TO: Mayor Trey King, City of Dacula
ATTN TO: Brittini Nix, Director of Planning and Economic Development, City of Dacula
FROM: Mike Alexander, Director, ARC Center for Livable Communities
RE: Development of Regional Impact (DRI) Review

Name of Proposal: Harbin 2 DRI 3700

Description: A DRI review of a proposal to construct a mixed-use development with 137,300 SF of commercial space, 304 multi-family units, and 53 townhouses on a 54-acre site on Harbins Road south of University Parkway in the City of Dacula.

WWP ACQUISITION, LLC
1958 MONROE DRIVE NE ATLANTA, GEORGIA 30324, PHONE: 404-872-8666
CONCEPTUAL MASTER PLAN

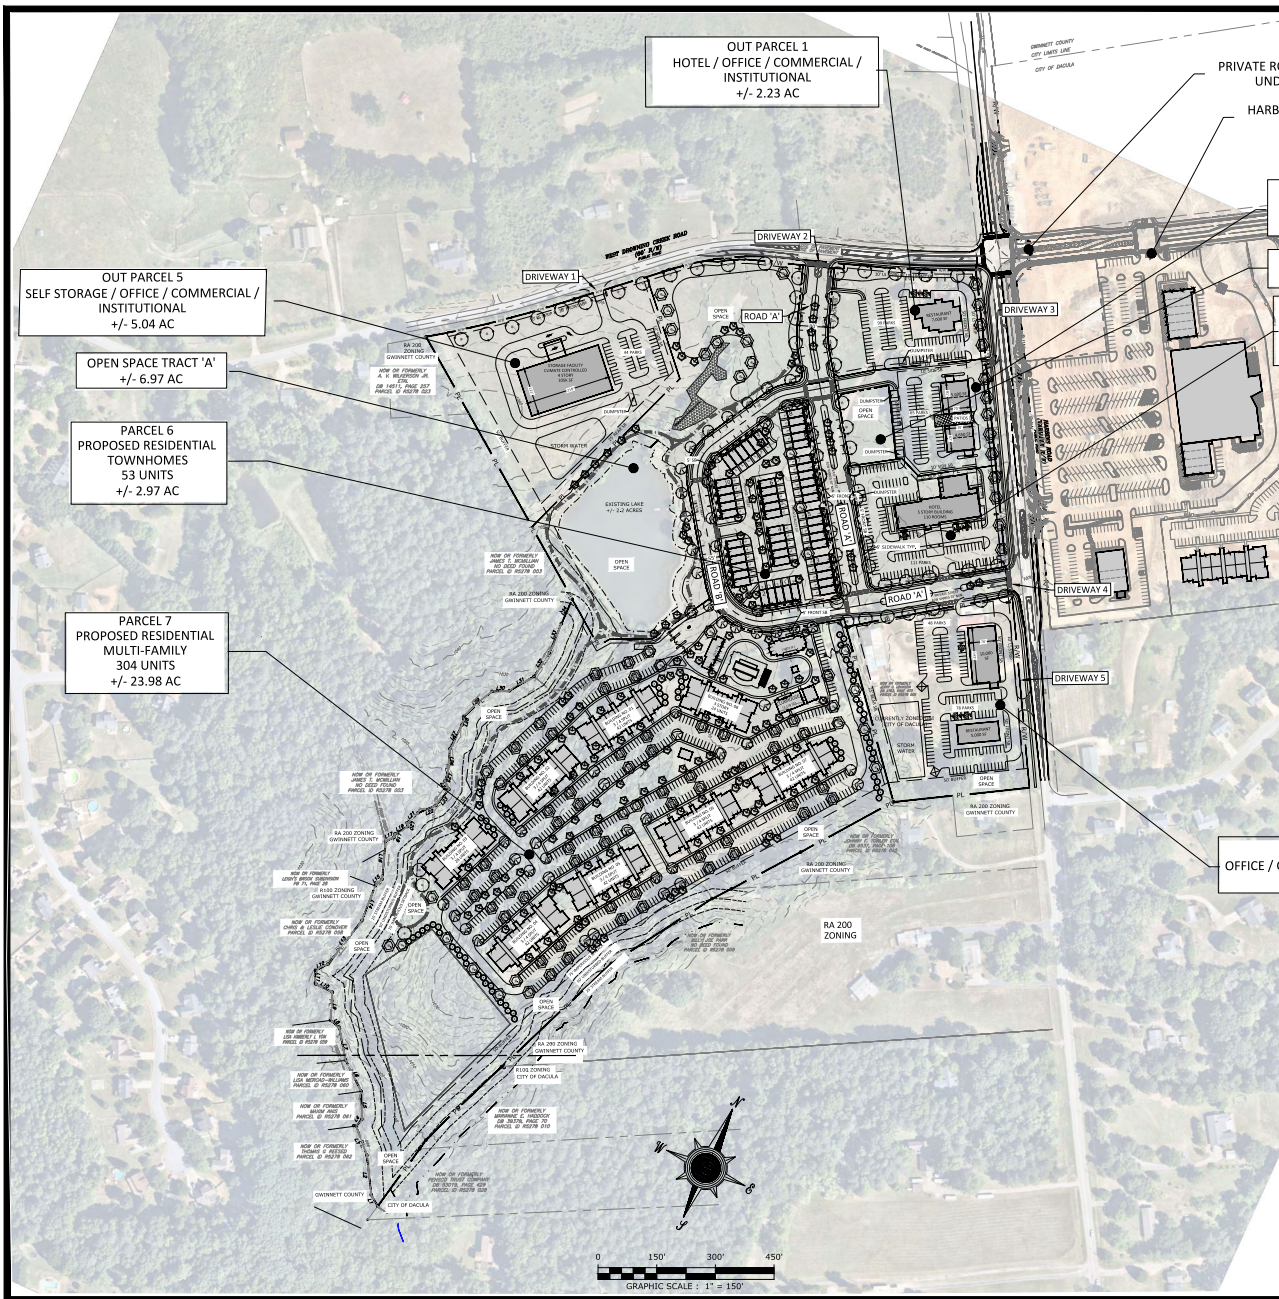
Incorporation of green stormwater and heat island mitigation designs for the approximately 1,056 surface car parking spaces proposed would be supportive of regional environmental policies.

The USGS coverage for the project area shows Palm Creek running along a short portion of the western/southwestern side of the project property and an unnamed intermittent tributary running along a portion of the southern side of the project property to its confluence with Palm Creek. The submitted site plan shows both mapped streams as well as an unnamed intermittent stream on either side of the existing lake and running along the western side of the property before it joins Palm Creek. The site plan shows and identifies the 25-foot State Sediment and Erosion Control buffer as well as the 50-foot undisturbed buffer and additional 25-foot (total 75-foot) impervious surface setback required by the City of Dacula Stream Buffer Ordinance on all streams except for the portion of the intermittent stream upstream of the existing lake. While this is in an open space area, the 25-foot State buffer should be shown on this portion of the stream. The City buffers should also be shown if the stream meets the minimum requirements of the City of Dacula buffer ordinance.

Except for walking trails, which are allowed in the buffers under the City ordinance, no intrusions into the mapped buffers are shown on the submitted project plan. However, some of the proposed development on the plans is very close to the 75-foot setback in several areas on the site plan. The City ordinance also requires that grading and earthmoving be minimized within the 75-foot setback. Grading within the setback may require variances from the City, as would any impervious intrusions. Any unmapped streams on the property may be subject to the City of Dacula Stream Buffer Ordinance and State 25-foot Sediment and Erosion Control buffer. Any unmapped waters of the state will also be subject to the State 25-foot Sediment and Erosion Control buffer.

Additional retention of existing trees on the site would be desirable and in keeping with regional goals regarding carbon sequestration and climate change/heat island effect mitigation. A substantial portion of the site along Palm Creek is shown as open space and water quality protection buffer areas. Designation of this area as managed open/conservation space could meaningfully reduce the overall impact of the project. There may be potential opportunities for linking these fragmented undeveloped areas with adjacent undeveloped or protected areas to ensure their maintenance and potential use for recreation or habitat preservation.
